SRC Comments
On M21, Revised Draft Monitoring Report, APWRA Bird Fatality
Study, December 2009

Alameda County Scientific Review Committee

The Altamont Pass Wind Resource Area (APWRA) Monitoring Team produced a draft report, Altamont Pass Wind Resource Area Bird Fatality Study (M21), in December 2009. Written comments on the draft report submitted by individual members of the Alameda County Scientific Review Committee (SRC) are compiled in this document. This document was updated as comments were received.

Figure 1. American kestrels

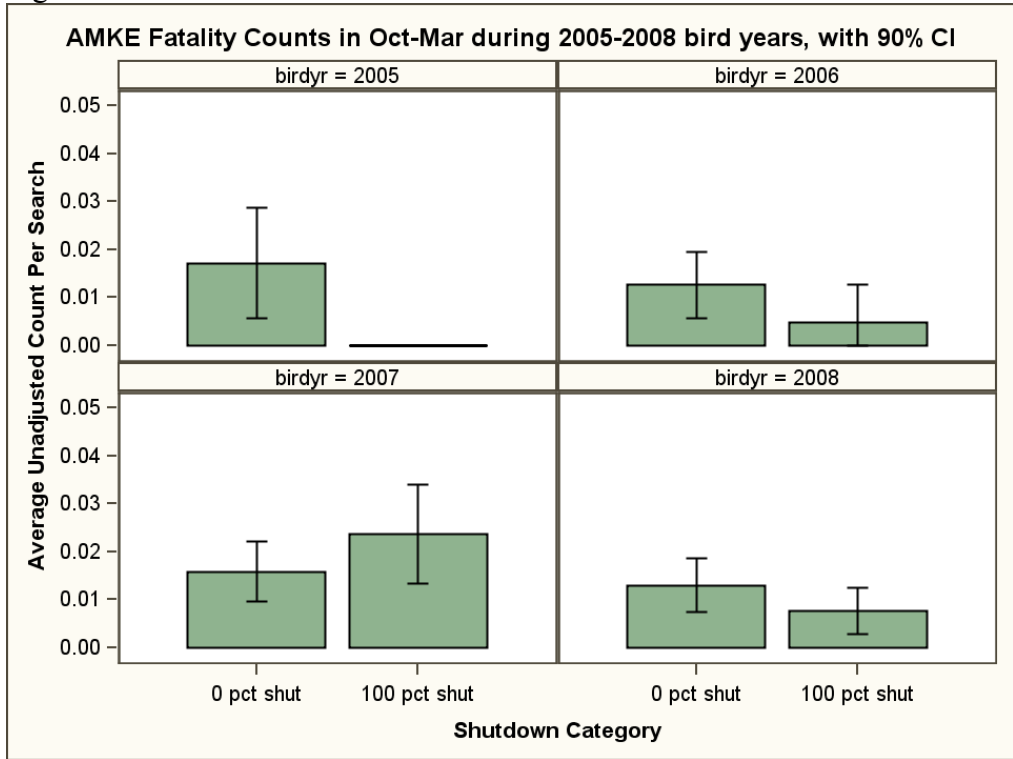
Finally, I constructed simple descriptive graphics by taking unadjusted fatality counts from each string search in which the string was shut down either 0% or 100% of the interval (Figures 1-4). These figures are consistent with the modeling results.
